P A S T
CONSULTANTS LLC

December 14, 2021

Re: 106 Cliff Ave., Capitola, CA – Preliminary Design Review Letter
APN. 036-112-17

Figure 9. Undated image of the subject property, showing the open porch and entrance on the west elevation.

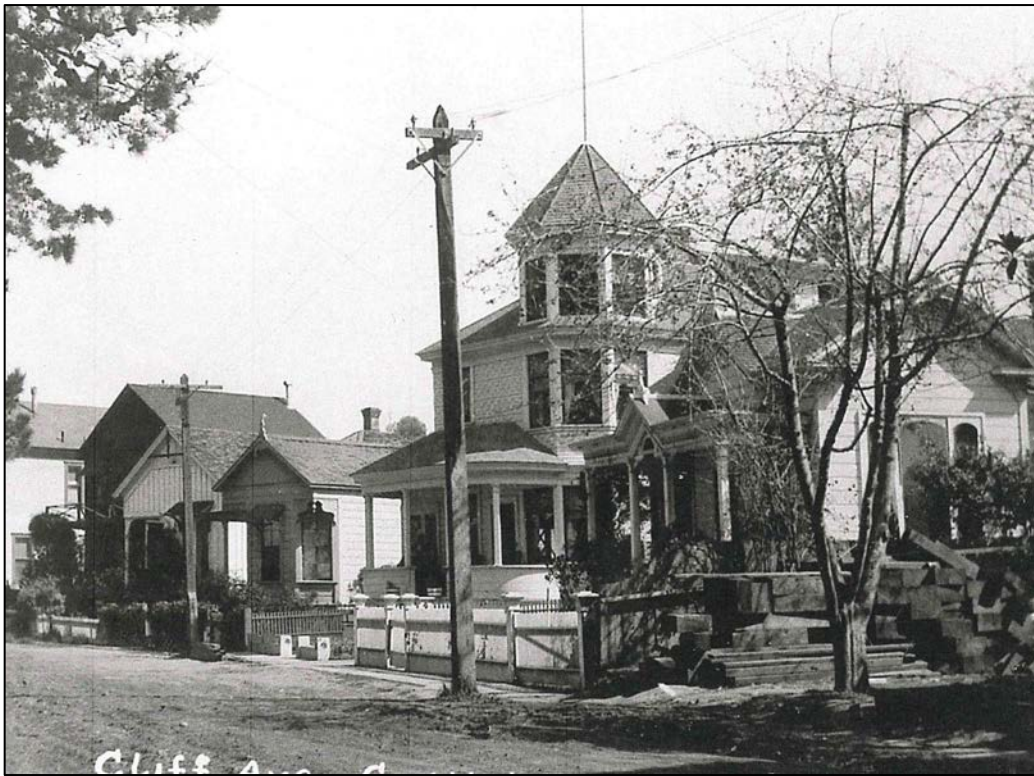
Since the porch enclosure is a recent addition and is not character-defining, returning the front porch to an open configuration is appropriate, but should be based on any existing photographs of the front elevation that show the porch's original configuration, such as shown on **Figure 9**.

1. Consider relocating the proposed south elevation fireplace chimney because it removes two character-defining windows from the south elevation.
2. Early historic photographs indicate that the tower was finished with wood shakes. A standing seam metal roof is not appropriate for the tower, based on the early photograph.
3. The rear addition should be sheathed in wood siding that differentiates it from the wood siding of the original house.
4. Consult early historic photographs to design an open front porch that does not create a conjectural design that is out of character with the Queen Anne style.
